Packet Guide
City of Charlottesville
Board of Architectural Review
Regular Meeting
February 22, 2023, 5:30 p.m.
Hybrid Meeting (In-person at CitySpace and virtual via Zoom)

BAR # 23-02-01

1516 East Market Street, TMP 560107000

Owner: Marial & Connor Childress Applicant: Marial & Connor Childress Project: Rear Addition and Porch

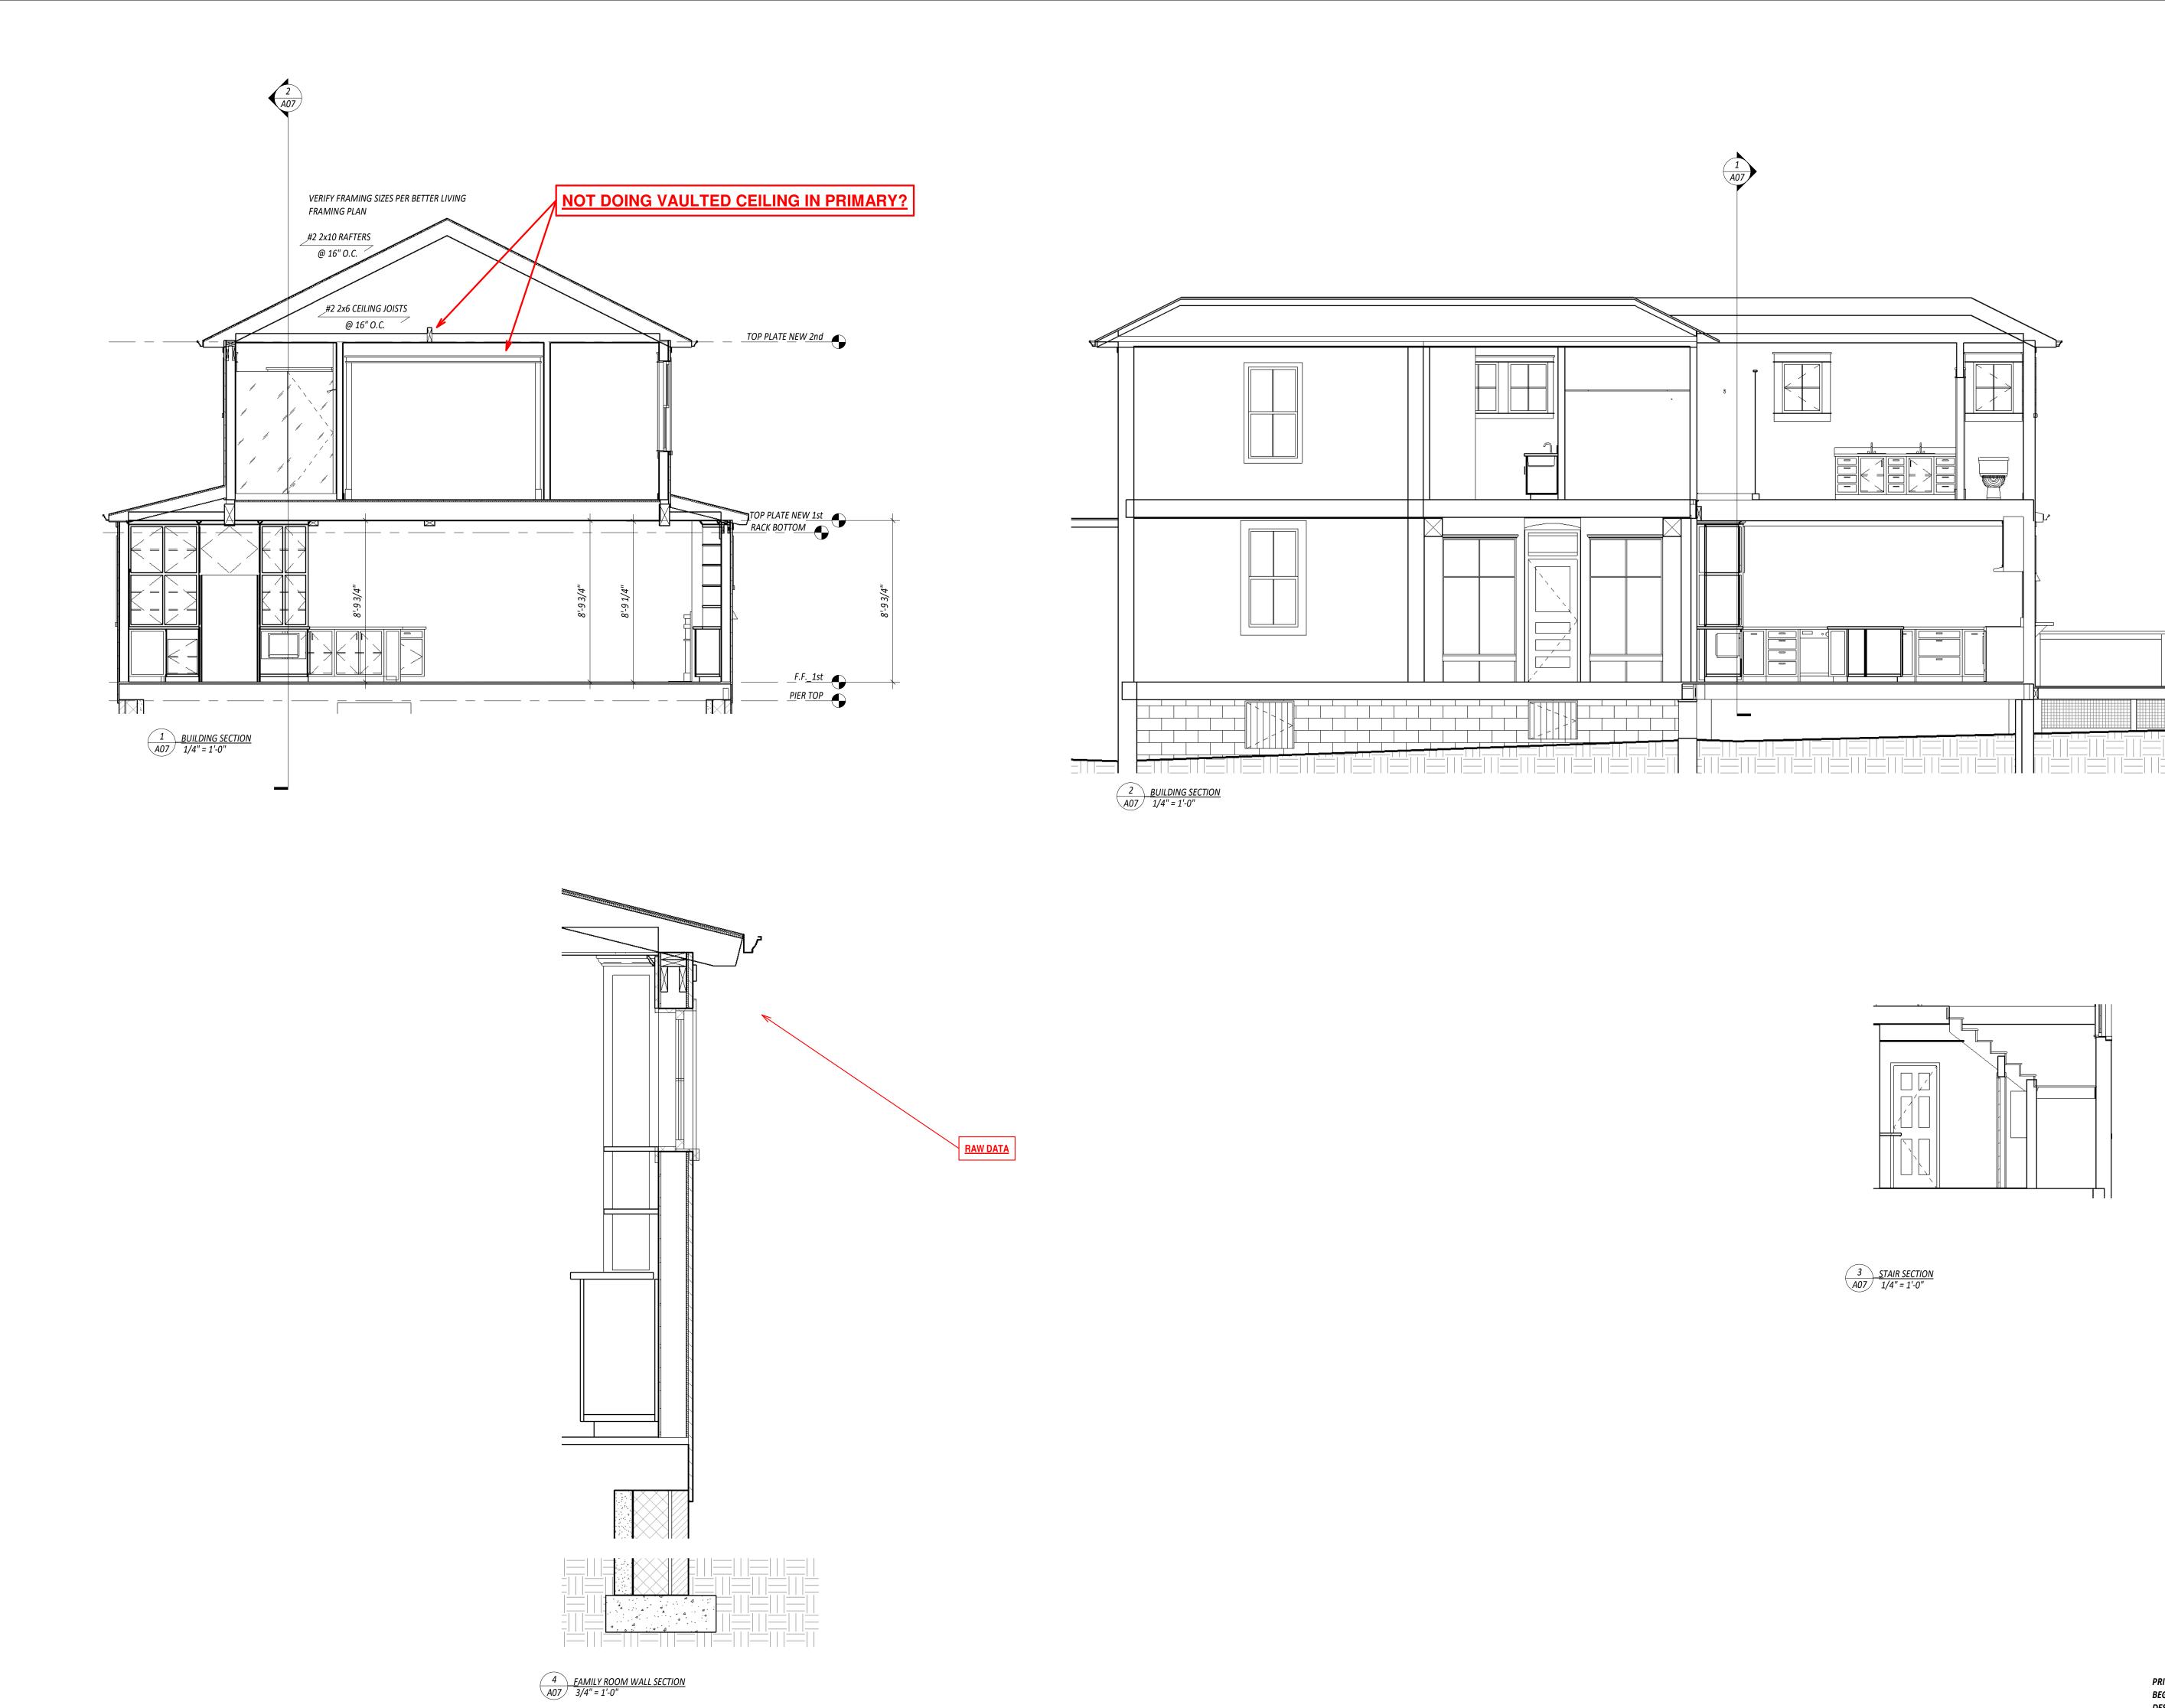
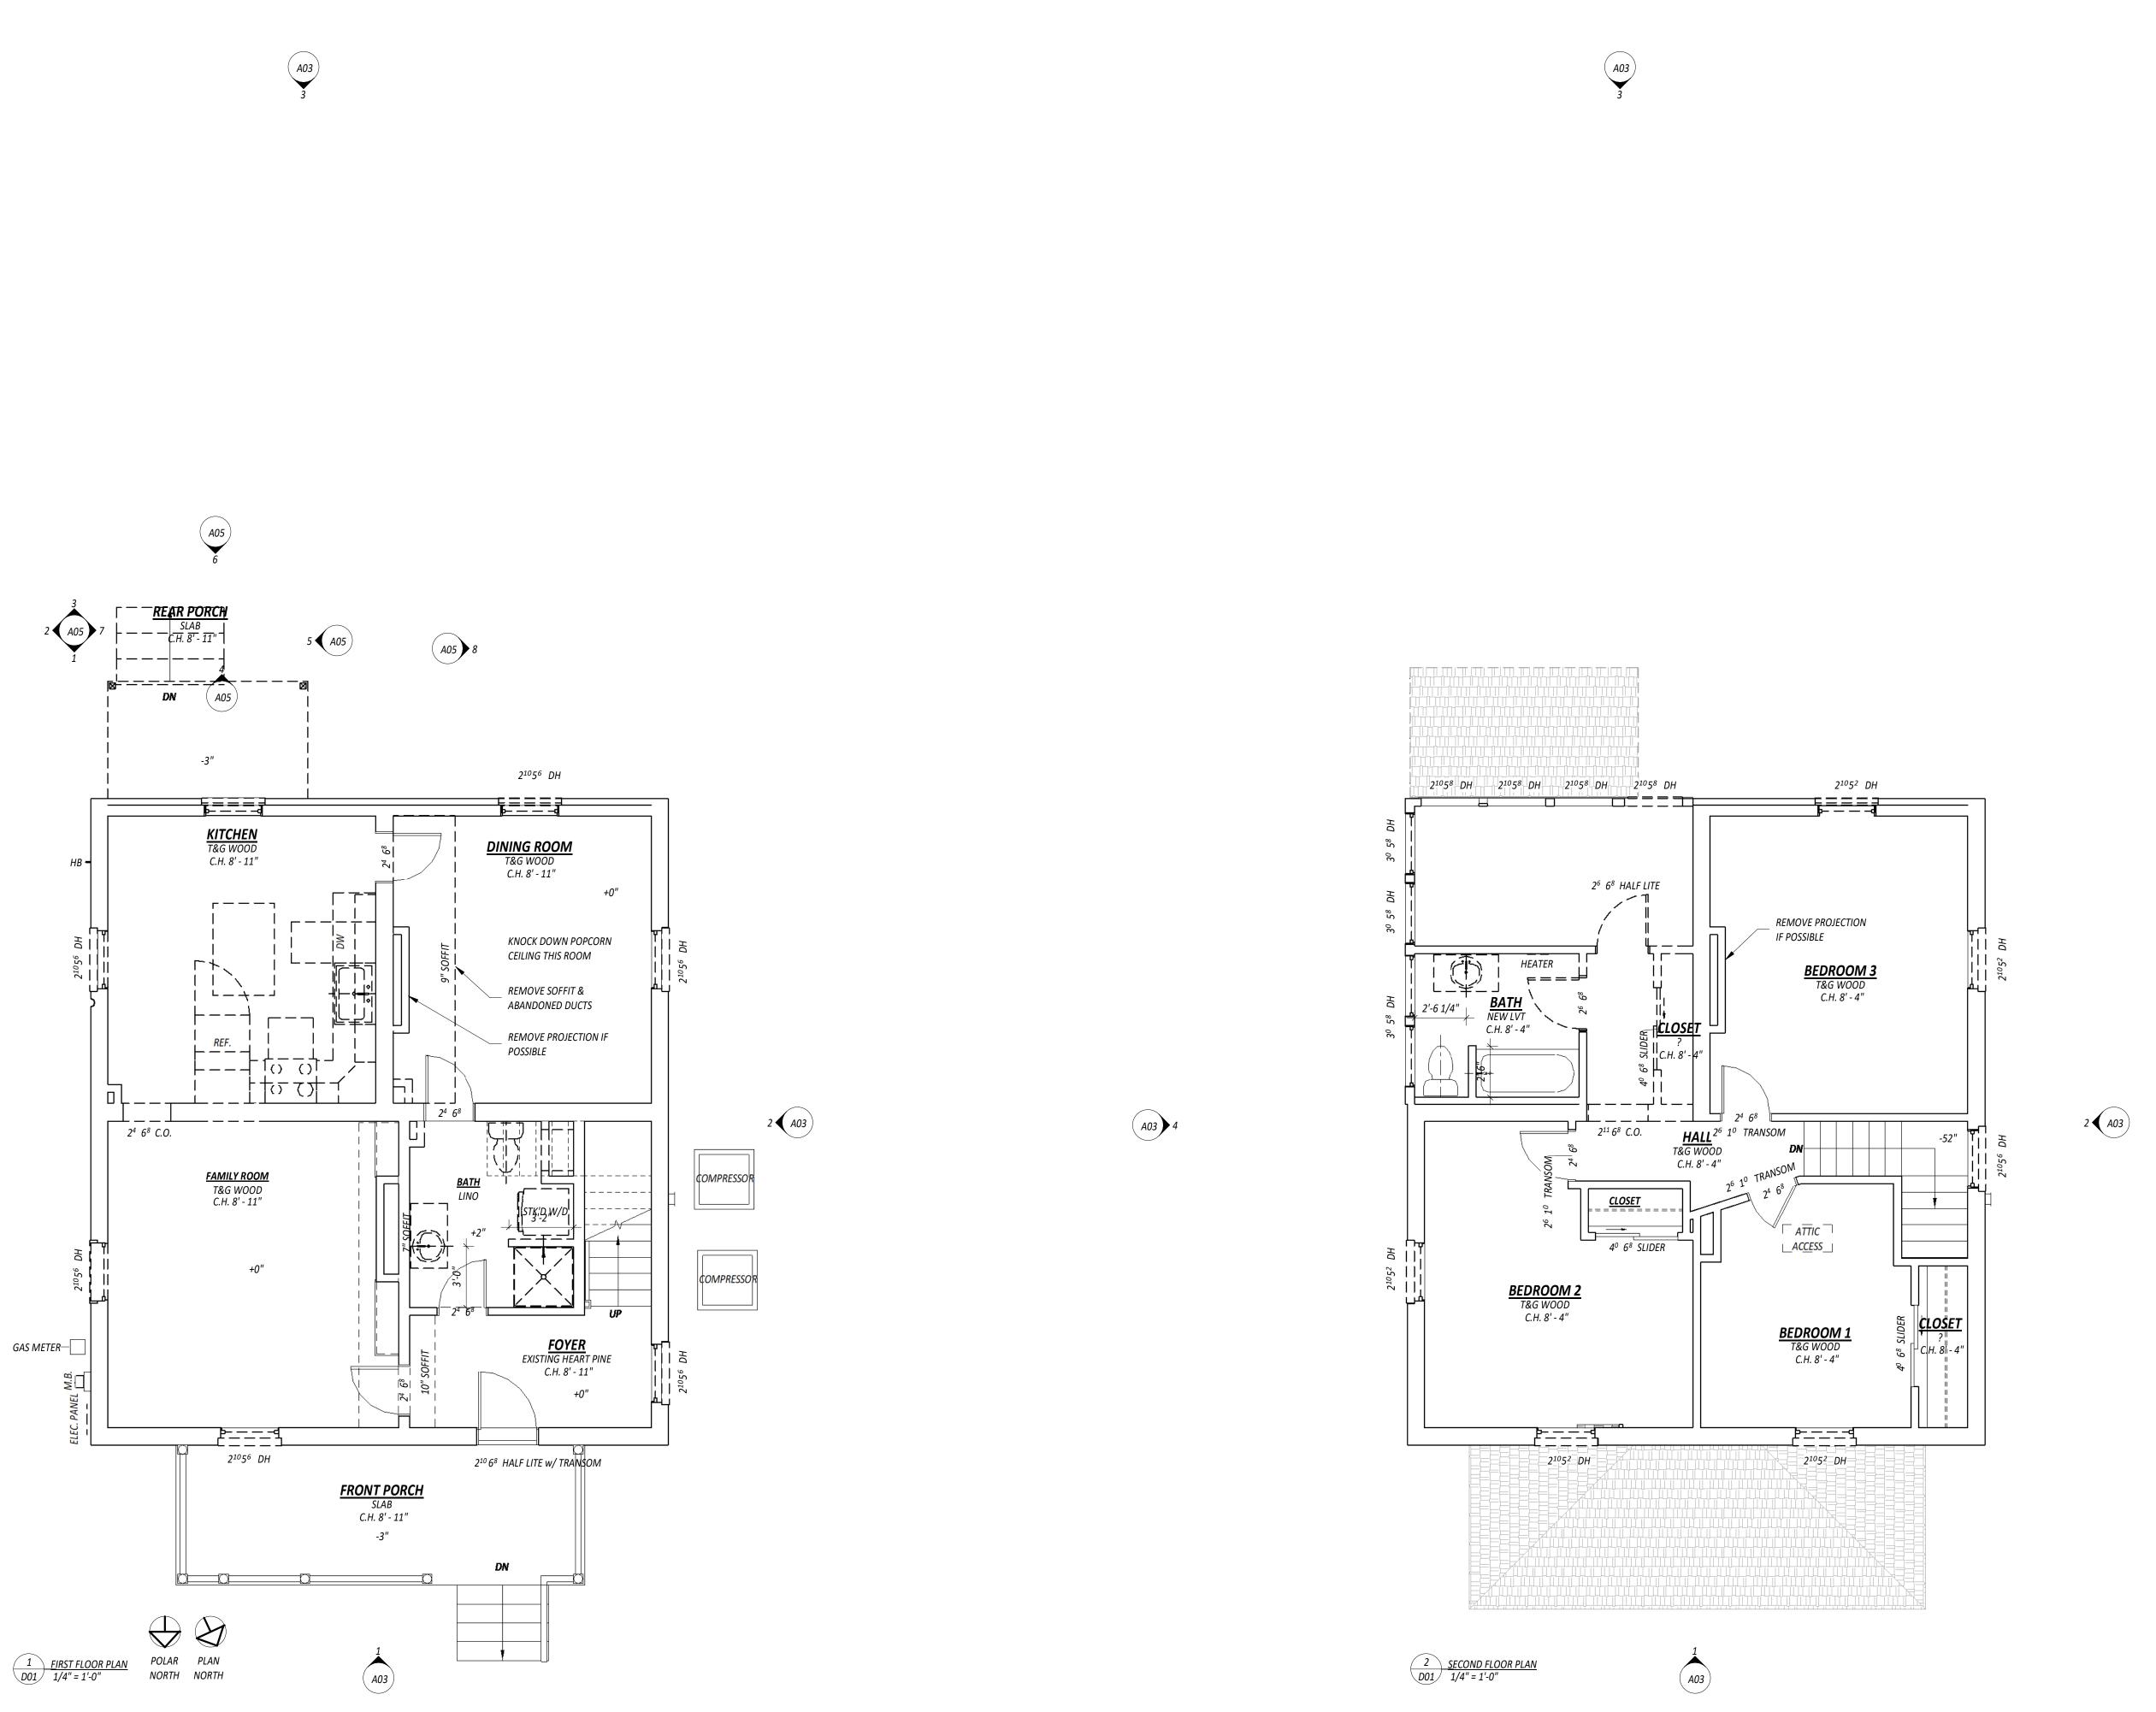
Question: On the east elevation, at the second floor, a former porch was enclosed with siding. The new addition, as presented, will continue the enclosed porch's wall plane, as if a continuous wall. For the new to *read as an addition*, staff suggested the applicant *push in* the new wall, creating a corner and a visual break from the existing wall. However, that would create difficulties with the planned interior space—the location of a structural beam. In lieu of creating a corner, a simpler solution is to install a [flat] *corner board* where the new meets the old and, possibly, alter the face dimension or the pattern
